CFS8DL6160RF-3 FCC C2PC COVER LETTER

This letter is to inform you of our request for a Class II Permissive change we are submitting for our transceiver known as CFS8DL6160RF-3. The transceiver will continue to operate under Part 15.231.

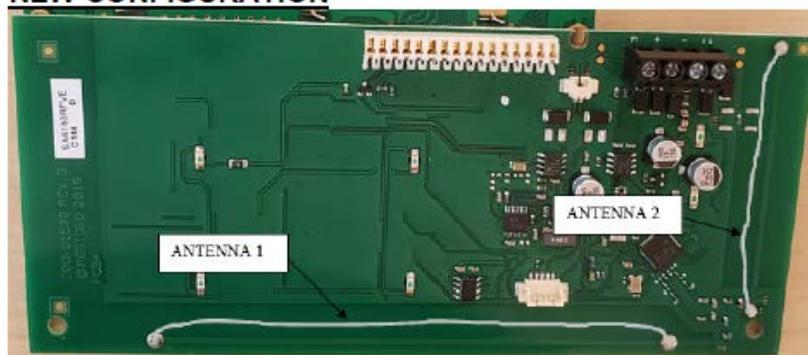
The change involves the antennas – the device is transitioning from PCB trace-type antennas to wire antennas. This change was initiated to improve the overall receive sensitivity of the device. Measurements of the fundamental along with spurious emissions and occupied bandwidth testing was performed to support the change. See before and after photos below.
